Arboricultural Consultancy

Mitchell Shire Council

Proposed residential development at
100 Natures Run, Kilmore

22 April 2021

Figure 3: Retention values assigned to trees on the subject site. Satellite image from Nearmap (19/03/2021).

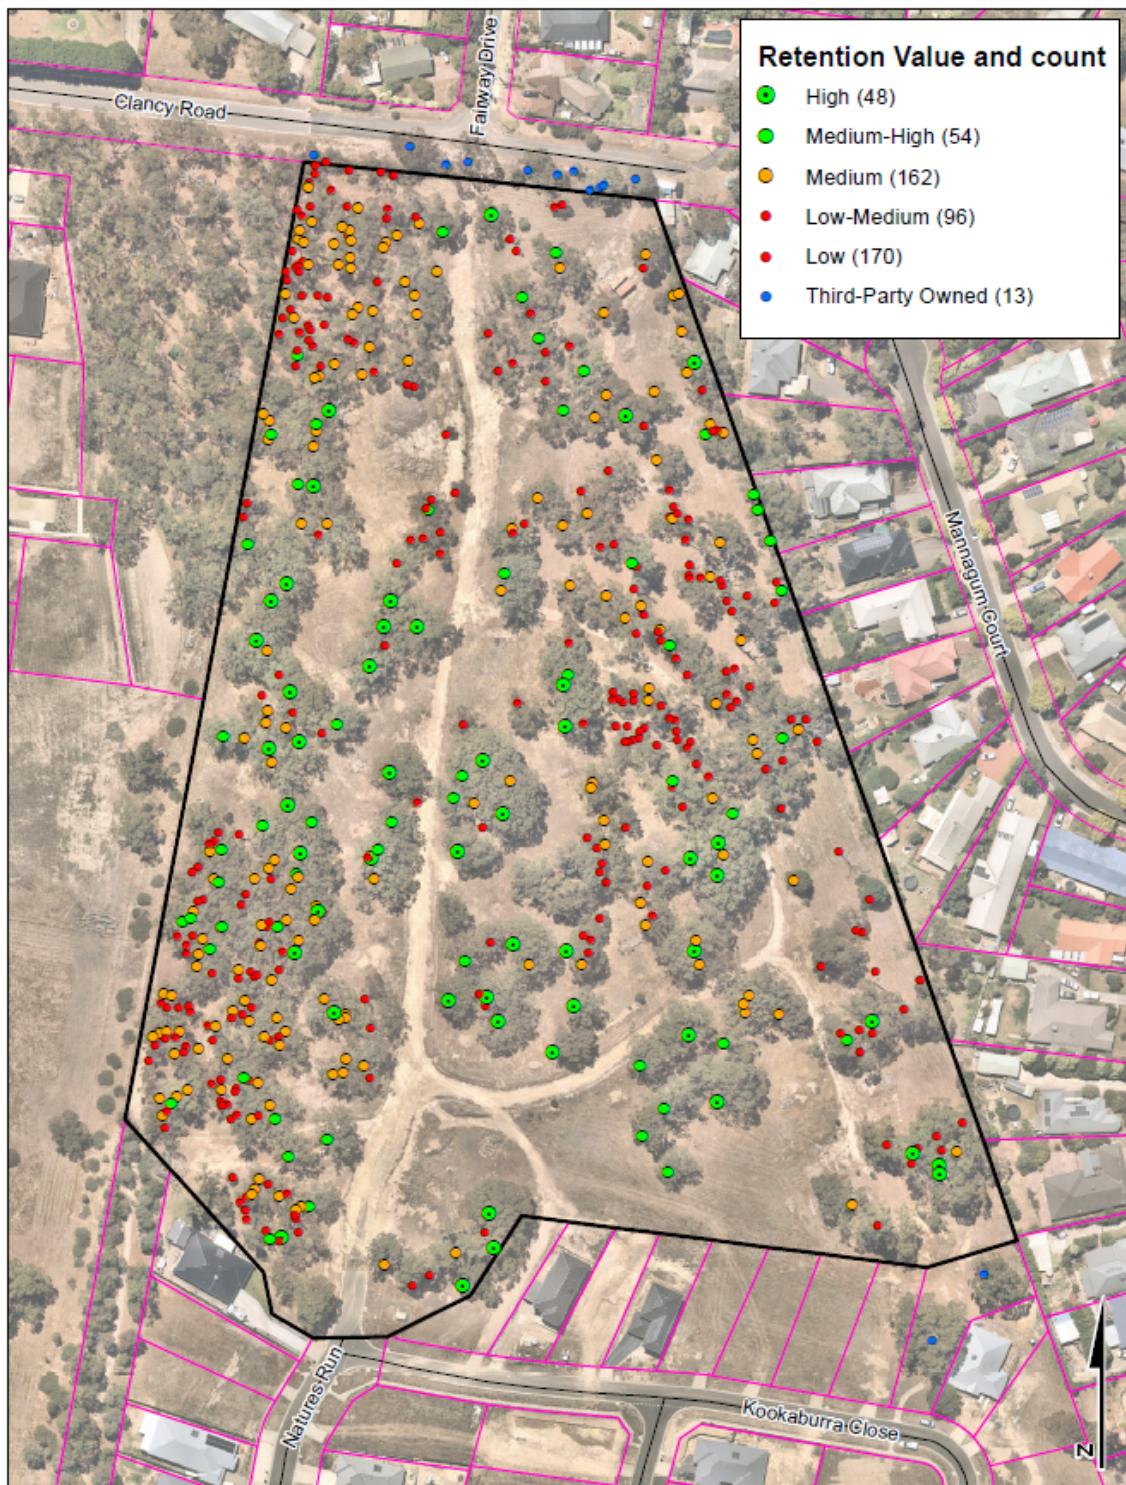
- A total of **48 High** retention value trees were identified on site. These are large, mature Eucalypts of high quality and are in good condition. They have the potential be a long-term landscape component where managed appropriately. They are the best trees on site and all efforts should be made to retain these trees and protect them from construction impact.

- Of these, 32 are *E. melliodora*, 10 are *E. goniocalyx*, 8 are *E. obliqua*, 2 are *E. radiata* and 1 is *E. viminalis*.
- A total of **162 Medium** retention value trees were identified on site. These are mature and semi-mature trees of moderate quality in fair or good condition. They may be medium to large trees with a health or structural issue that can be resolved with arboricultural input, or small to medium trees in good condition. These trees have the potential to be a medium to long-term landscape component where managed appropriately and where practical, design modifications should be considered in order to retain and protect them from construction impact.

Figure 4: Hollow bearing trees, large dead trees of habitat value and scattered trees. Plotted location has been overlaid on the Tree Removal Plan prepared by Human Habitats.

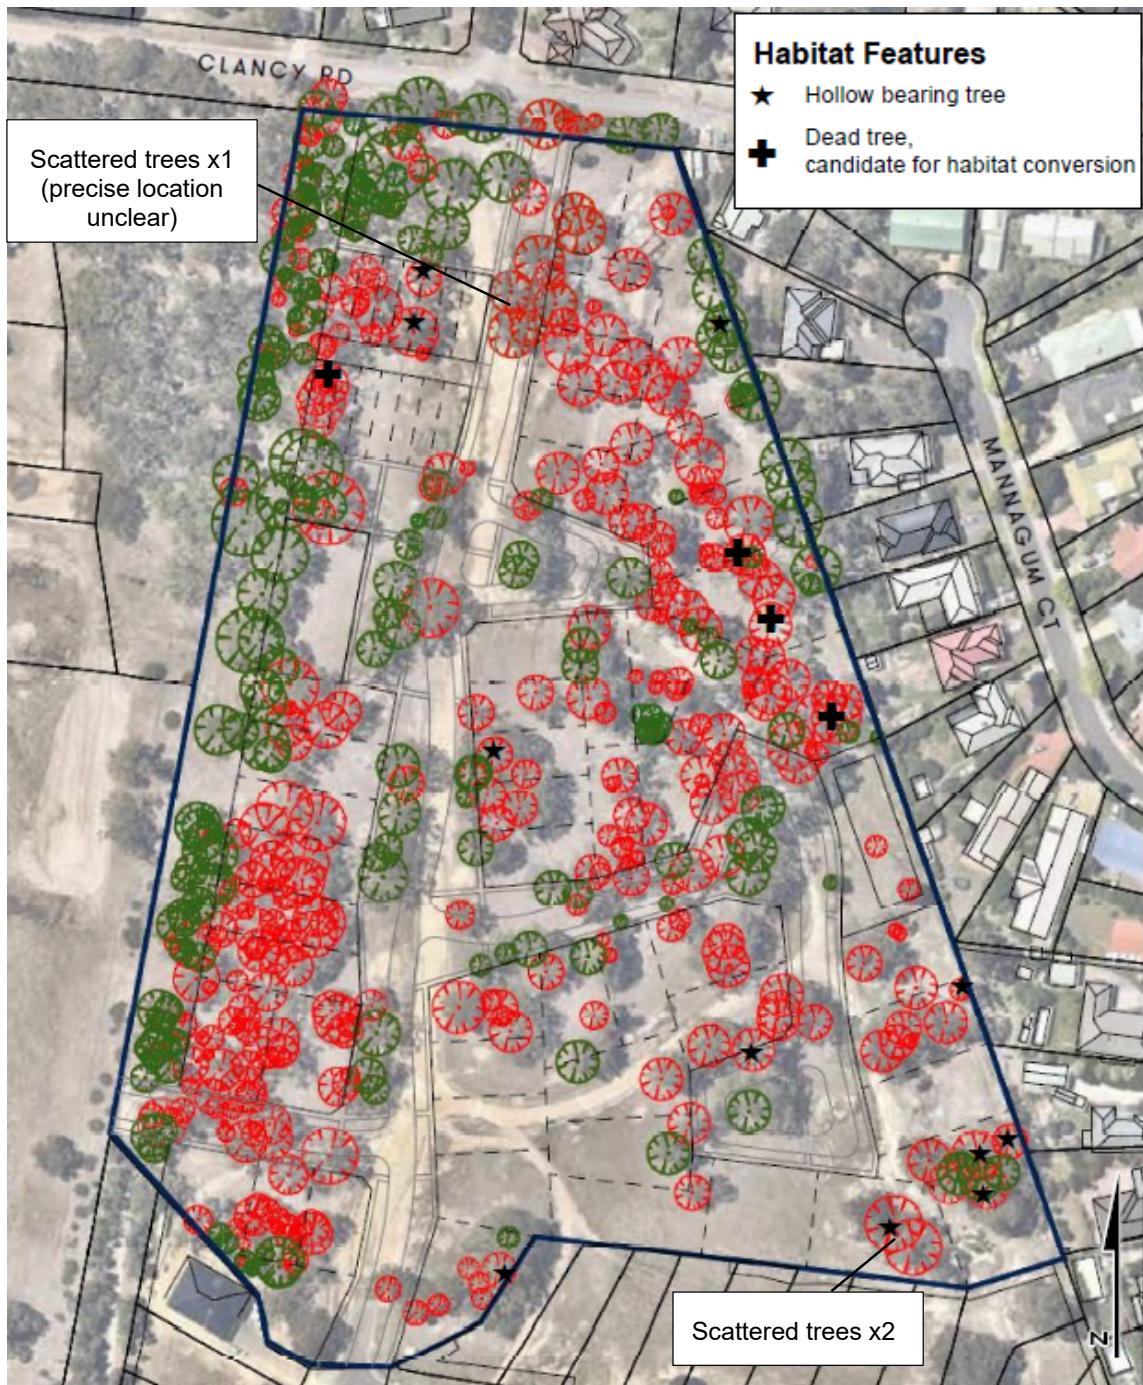
The best of these is Tree 360, which has a DBH of 120cm. Also of value are Trees 8, 44, and an unlabeled tree (possibly Tree 47), all with DBH at about 80cm. The development plans appear to indicate all four are proposed for removal (Figure 4). Photographs of these trees are shown in Figure 5 - Figure 8.

It appears that 10 of the 11 trees identified as bearing hollows are proposed for removal, as are all three scattered trees identified in the Cardno Flora and Fauna Assessment.

Figure 13: Stands and clumps of vegetation across the property.

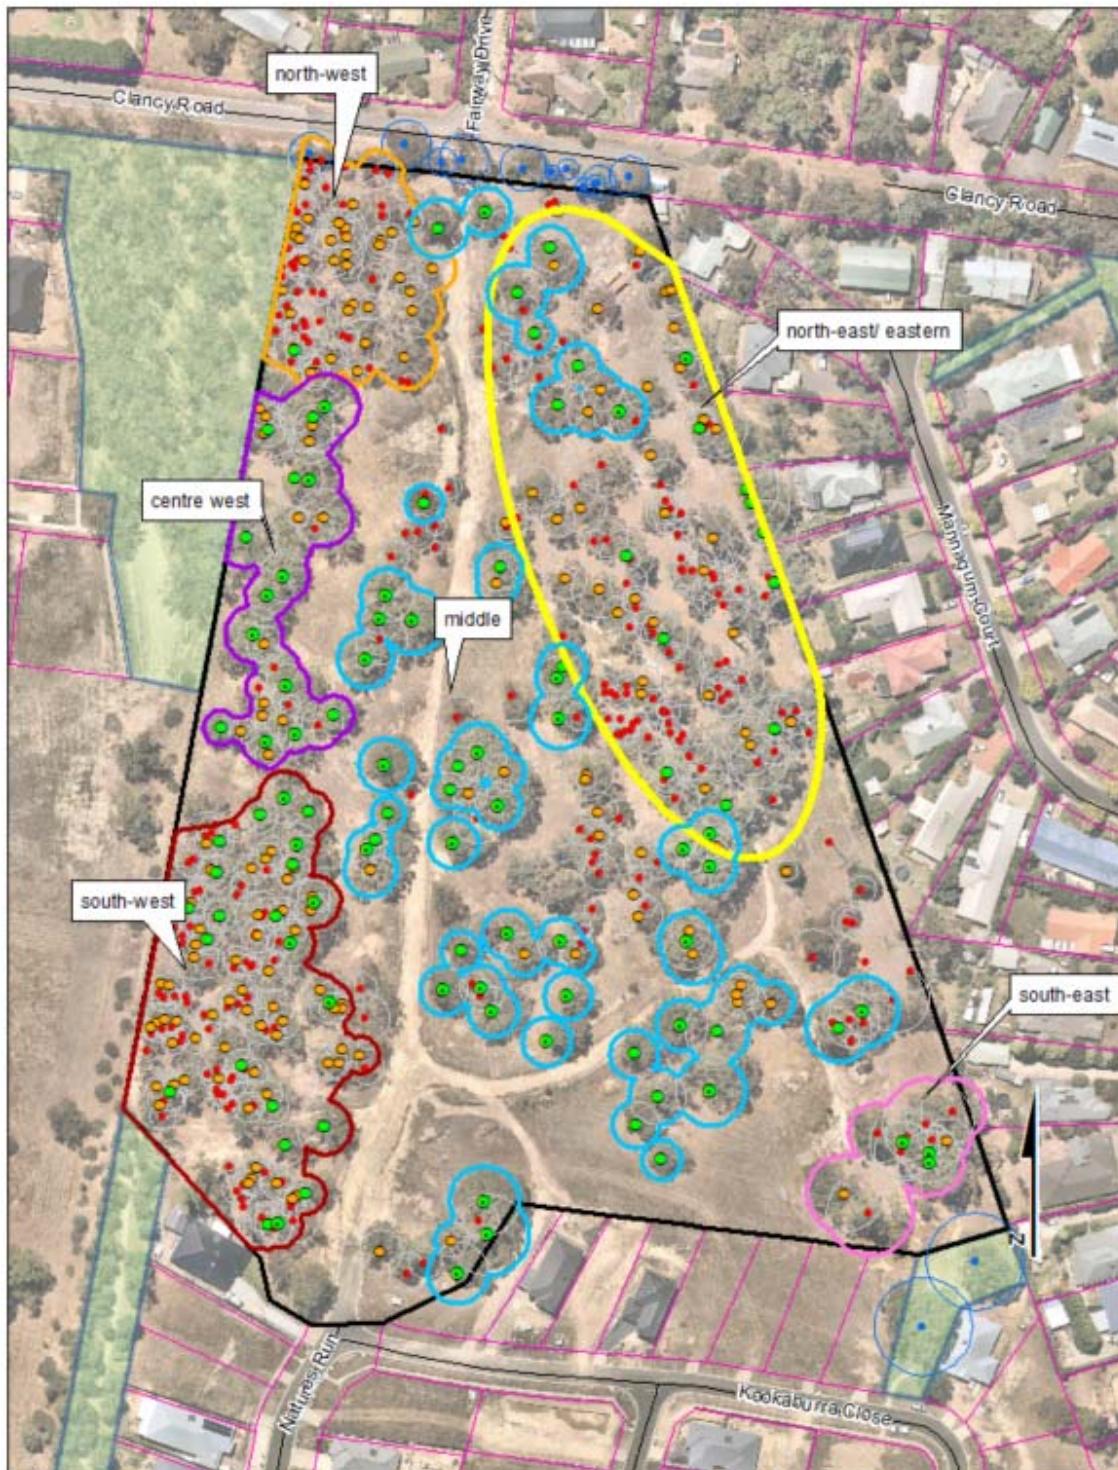
The **centre-west** section of the property is dominated by mature *E. melliodora* with a few *E. obliqua* and *E. goniocalyx* to the north, including one very large dead *E. obliqua* with potential habitat value (Tree 360). The *E. melliodora* are growing in an open grassy woodland with little understorey and while there are some unforested gaps in this area, the tree canopies maintain connectivity. Individually, about 40% of the trees have High and Medium-High retention value, and 40% have Medium retention value, with only 20% of lesser value. This area of trees is significant due to both the value of individual trees, and as a group in providing connectivity between existing vegetation corridors. The group of trees warrants retention as an intact landscape unit, with the exception of any hazardous trees.

The **south-west** section of the property is forested by a moderately dense woodland of *E. melliodora* and *E. goniocalyx* with a grassy understorey. Approximately 16% have High and Medium-High retention value (mostly *E. melliodora*), ~37% have Medium retention value, and ~47% have lesser value. While the trees vary in size, condition and retention value, disturbance in this area is minimal relative to much of the property and the group of trees is significant and vital to retaining connectivity between existing vegetation corridors. This group of trees warrants retention as a largely intact landscape unit, maintaining as large and intact a contiguous patch of vegetation as possible, as well retaining as many High and Medium-High individual trees as possible.

The *E. melliodora* and *E. goniocalyx* woodland in the south-west is largely nominated for removal. As discussed in Section 2.2.2.4, this forest contains trees varying in size and condition with High and Medium-High individual trees throughout. The largely undisturbed patch is significant and vital to retaining connectivity between existing vegetation corridors (Figure 33). A narrow strip of vegetation is proposed for retention along the western boundary but the removal of the bulk of the trees to the east will expose the retained strip and reduce the structural diversity of the stand, reducing its value as a vegetation corridor and likely reducing the Useful Life of the individual trees.

The north-east/ eastern swathe of vegetation is also largely nominated for removal. This area includes open grown *E. goniocalyx* and *E. melliodora* on the flats, many of which should be targeted for retention, and *E. goniocalyx*/ *E. obliqua* forest on the slope, including some large, veteran *E. obliqua* trees along the eastern boundary. The veteran trees are nominated for retention on design plans, but the removal of almost all vegetation in proximity will isolate these trees in the landscape, potentially contributing to their demise and reducing their habitat value. The plan depicts these trees along the shared back fence of existing and proposed residential lots. As these trees age and decline they will require increasing input to manage and maintain in a safe condition in a solely residential setting and will quite possibly require premature removal.

Figure 25: Tree 553: *E. melliodora*, WOR 5-6.
High retention value, nominated for removal.

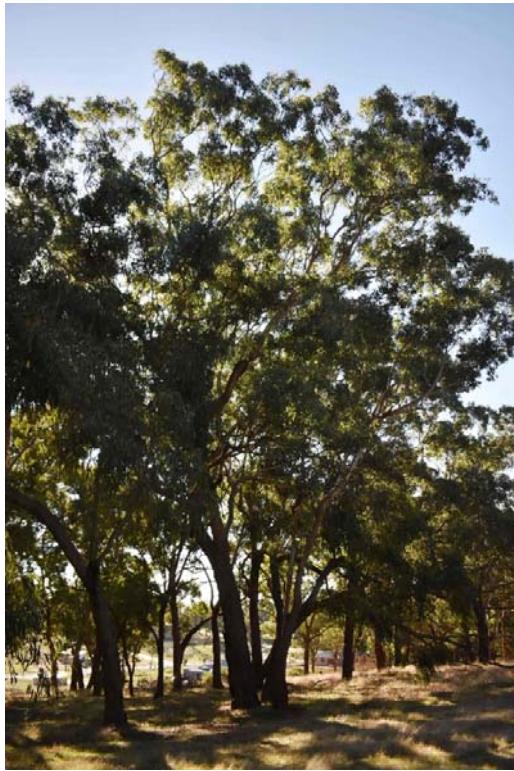
Almost all labelled trees attributed WOR 6, and WOR 5-6 in the Galbraith Report are also significant and are considered to have High or Medium-High retention value. These are large, mature, indigenous trees with Fair to Good health and structure. They currently provide a positive contribution to the local landscape and will, given the opportunity, continue to contribute to the neighbourhood character for decades to come.

Examples of WOR 5-6 and WOR 6 trees with High retention value are shown in Figure 25 to Figure 28, all are nominated for removal.
